August 20, 2020

**RE: Notice of Application Incompleteness**  
**Project Name: Saticoy East Village Commercial Center**  
**Project Number: 10484**  
**Case Number(s): DRC-6-20-55396; PD-6-20-55397; UP-6-20-55398**  
**Project Location: Southeast Corner of Wells Road (State Route 118) and Darling Road**  
**APNs 090-0-280-245, -265, - 395**

# Amended Site Plan Circulation and Building Placement Concerns

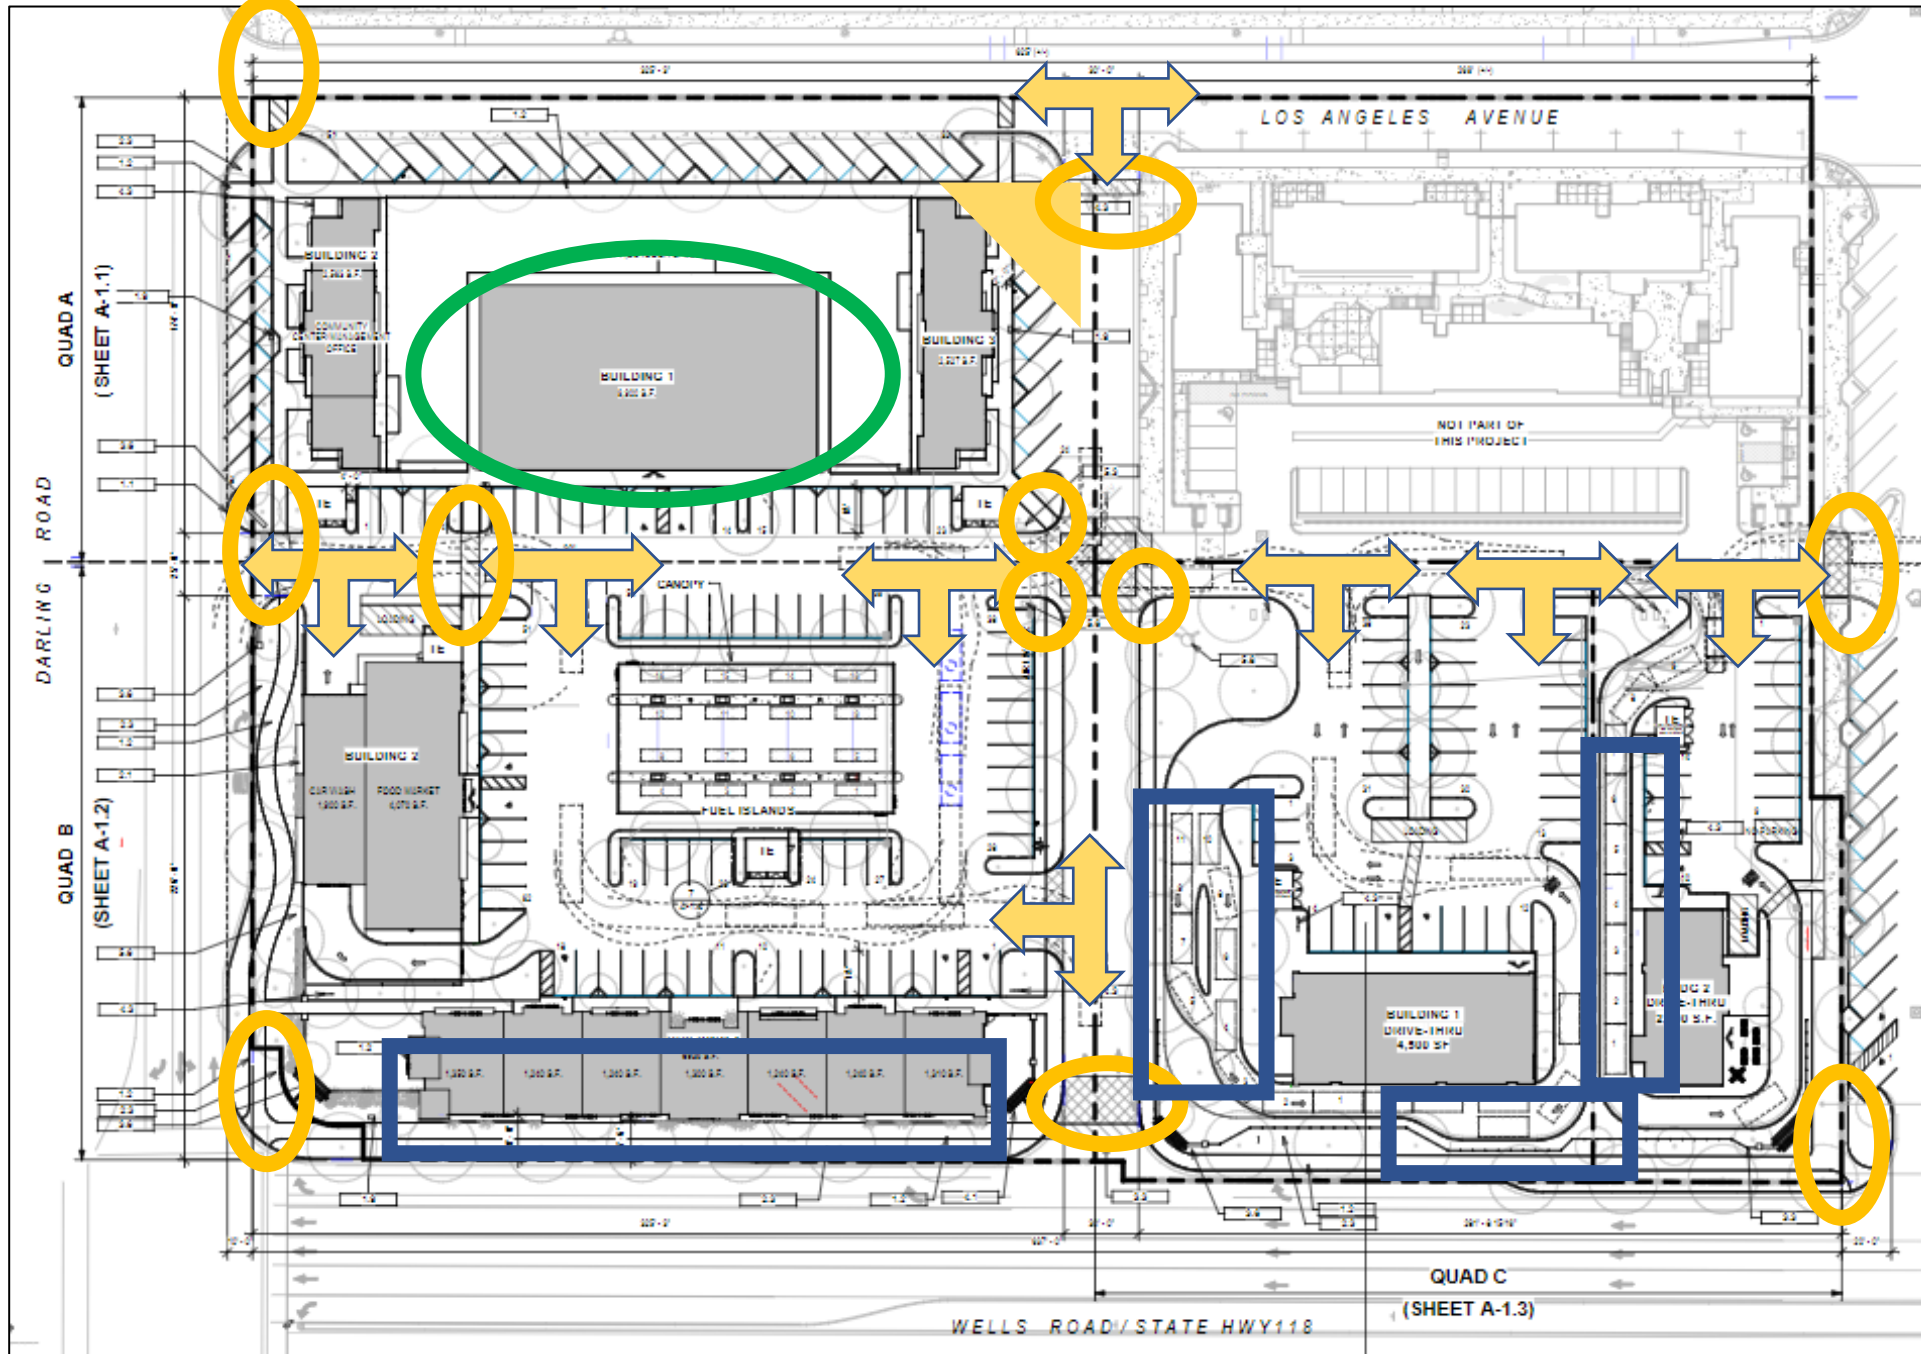
Day Care Building needs to be oriented to Los Angeles Avenue

Vehicular Ingress/Egress and Adjacency to Street Parking

No street parking allowed within 50 feet of Los Angeles Avenue.

Pedestrian connection points

Drive-through queue and Building Encroachments
